Observation Report

Re: Meadow Creek Condominiums, Vail, CO
(Building K)
Project No. 0307-19 K

(Image A, Unit 1 & 2)

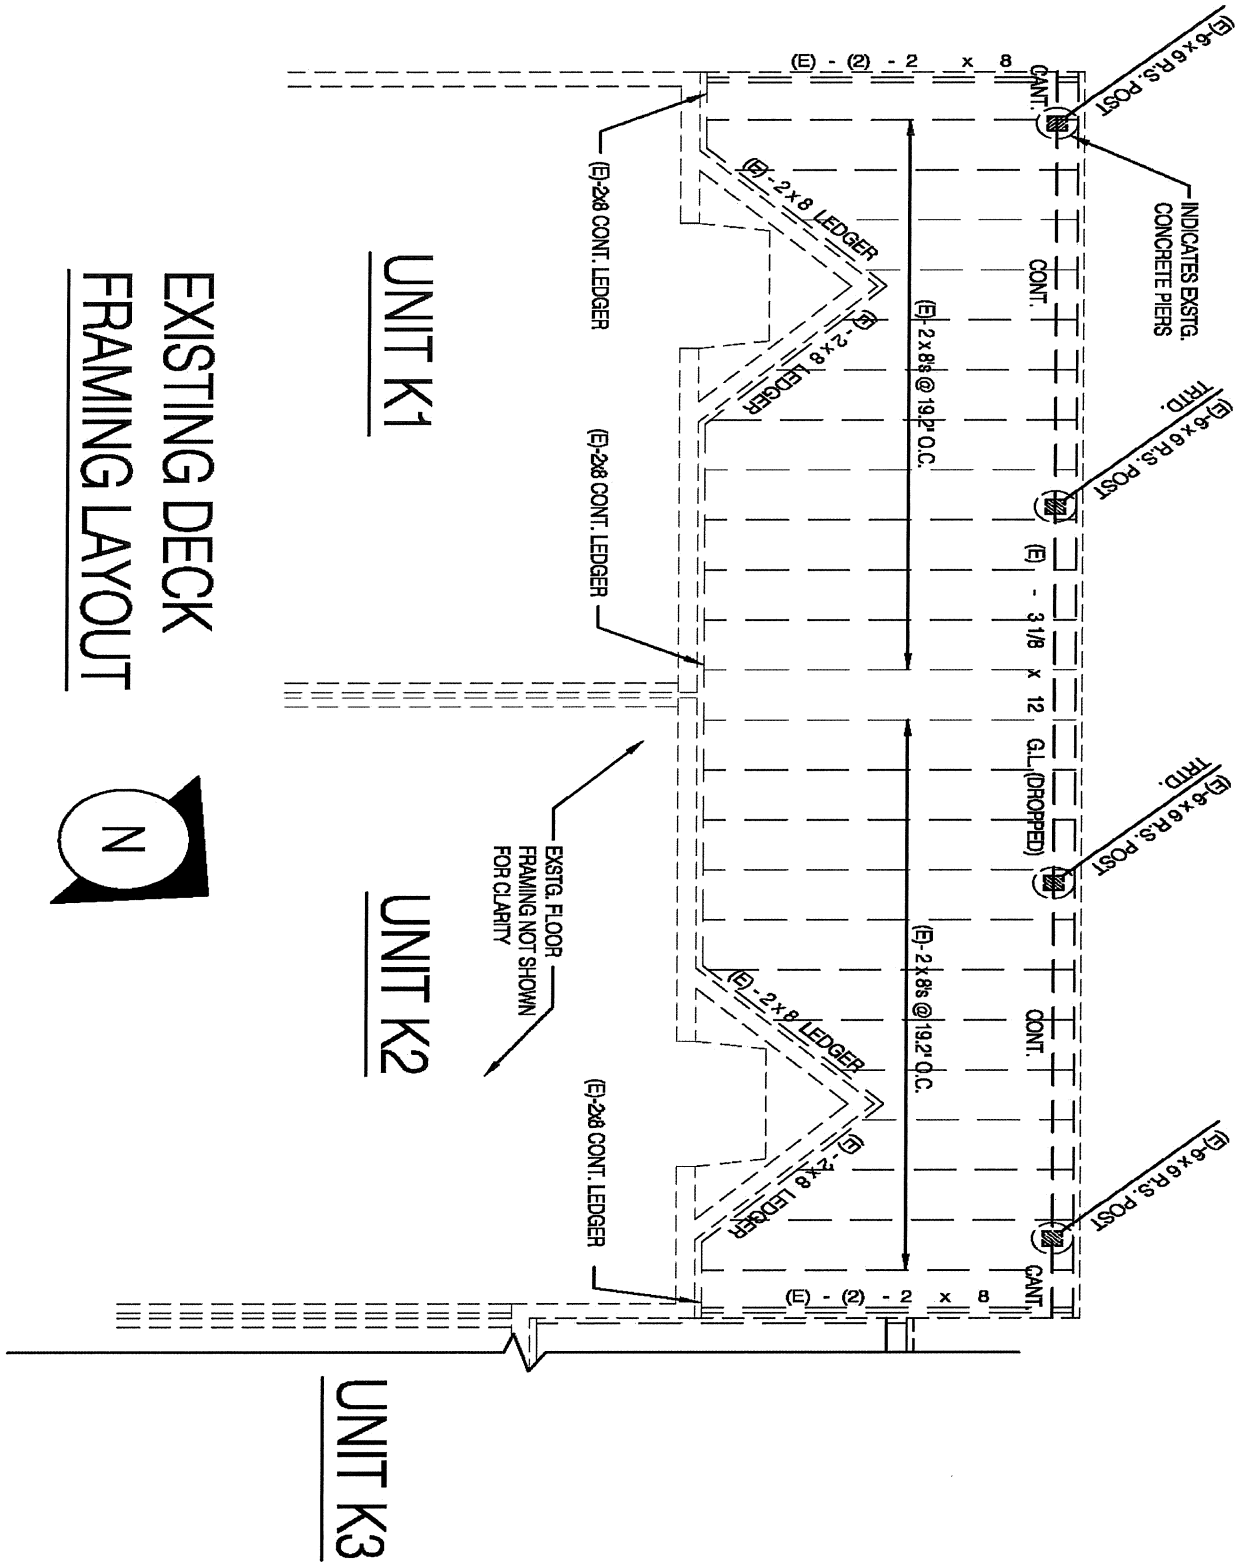
Building K consists of four units and staggers two units at a time from the northeast towards the southwest approximately 4 feet starting with units K4 and K3. The decks appear to have been remodeled at some point in time. The exterior decks are located on the west side of the building and are approximately 10'-9" above the finished grade. They extend approximately 9'-6" from the building and the span the length of the K building. There is a framed partition wall that divides the decks in half. This partition wall appears to be located between the two units at the party wall. The decks are accessed by an exterior door located on the west side of each individual unit. The exterior decks appear to be framed with 2x wood decking on 2x8 deck joists spaced at 19.2" apart. Most of the joists bear on mechanical steel hangers or are toe-nailed on the east end and cantilever approximately 8" on the west. The east end hangers are nailed to either a 2x8 ledger that is perpendicular with the deck joists or toe-nailed to a 2x8 ledger that is on an approximate 45 degree angle to the deck joists. The ledgers appear to be nailed to the side of the building. The cantilevered ends of the joists bear on a dropped 3 1/8 x 12 glulam beam. Some of the deck joists and nails appear to be weathered and show signs of rust. (See Image A, B, C, D and attached layouts)

Units K1 and K2: The glulam beam for these units spans continuously over four 6x6 rough sawn posts. The largest span appears to be on unit K1 and is approximately 12'-4" in length. The largest cantilevered span appears to be on unit K2 and is approximately 2'-4" in length. The post to the north of unit K1 appears to have a vertical crack along the length of the post. The top of all the posts appear to have a notch at the top where the glulam beam bears. There does not appear to be a mechanical steel cap or any type of bolts connecting the two members together. All of the posts bear on concrete circular piers and do not appear to have a mechanical steel base plate. The concrete pier to the south of unit K1 appears to be only 3 to 4 inches above the finished grade. (See Image E & F)

1. Provide Simpson ABU66Z base plates to all 6x6 posts.
2. Add (3)-4" x 3/16" diameter Timber-Lok screws at 16" on center to all existing 2x8 ledgers that are attached to the building rim-board.
3. Replace all deck joists that are showing any signs of rot with new ones.
4. Add (2)-1/2" diameter through bolts to the glulam and the top of the 6x6 posts spaced six inches apart from the center of the beam.
5. For unit K1, replace the 6x6 post that has the vertical crack in it and provide a base plate and bolts as described above.

(Image B, Unit 3 & 4)

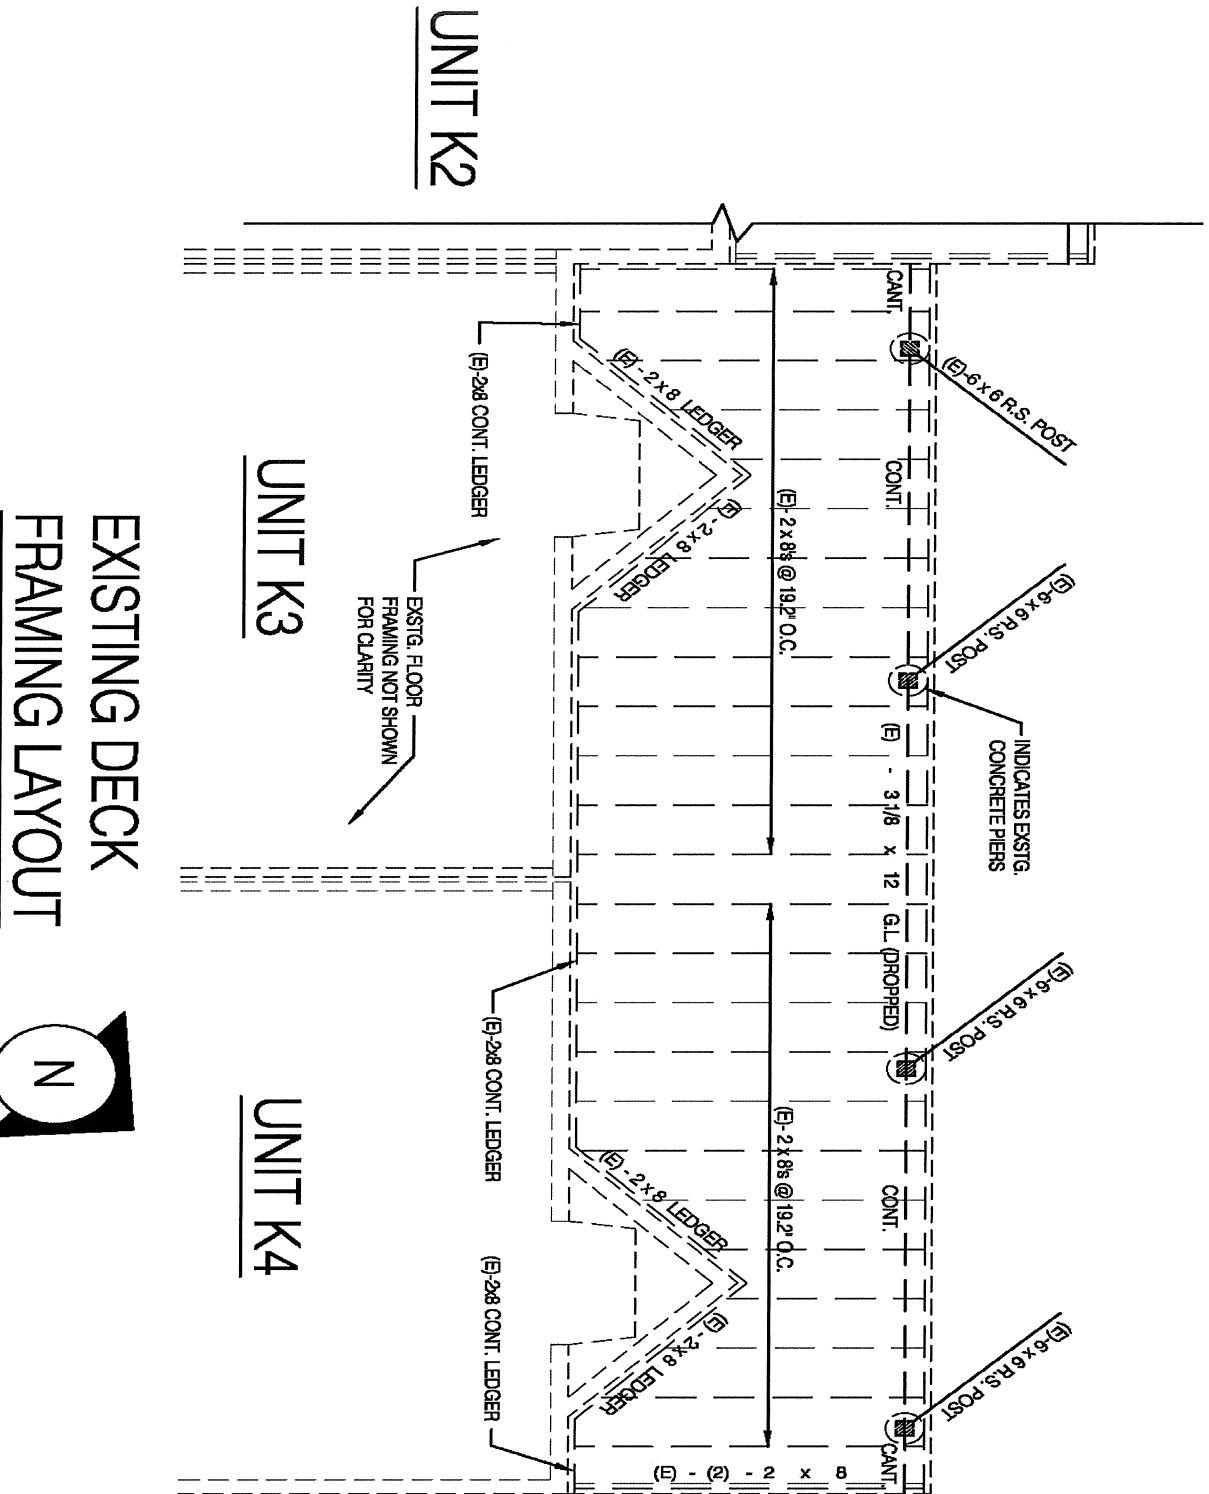
Units K3 and K4: The glulam beam for these units spans continuously over four 6x6 rough sawn posts. The largest span appears to be between both units and is approximately 12'-7" in length. The largest cantilevered span appears to be on unit K3 and is approximately 2'-9" in length. The top of all the posts appear to have a notch at the top where the glulam beam bears. There does not appear to be a mechanical steel cap or any type of bolts connecting the two members together. All of the posts bear on concrete circular piers and do not appear to have a mechanical steel base plate.
